Notice of Adding Sight Glasses on the Traversing Gear Cover (7.5t~30t Double Rail type)

Subject	Notice of Adding Sight Glasses on the Traversing Gear Cover (7.5t~30t Double Rail type)	Date of issue	May 13th ,2015	Notified to
		MITSUBISHI ELECTRIC FA INDUSTRIAL PRODUCTS CORPORATION 1-1-1 Imajuku-Higashi, Nishi-ku, Fukuoka 819-0192 TEL 092-805-3400		Sales agent

With rubber bushes	Without rubber bushes	The view of gear tooth surface from sight glasses

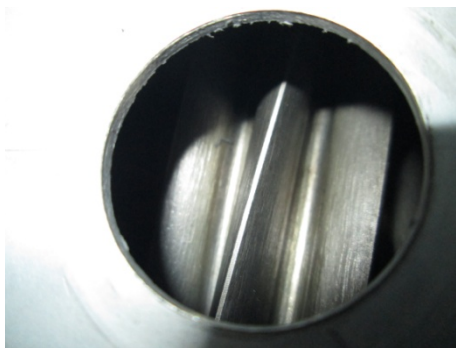
Adding sight glasses (3x ϕ 30 hole + rubber bush) on the traversing gear cover for easy inspection.

Cap. (t)	Parts Name	Parts code		Remarks
		Existing product	Switching product	
7.5t~30t	rubber bush	—	03H56E	Adding parts code
7.5t, 10t	cover (foreside)	03H472	03H472	Parts code : No change, Adding sight glasses
15t~30t	cover (foreside)	03H473	03H473	Parts code : No change, Adding sight glasses
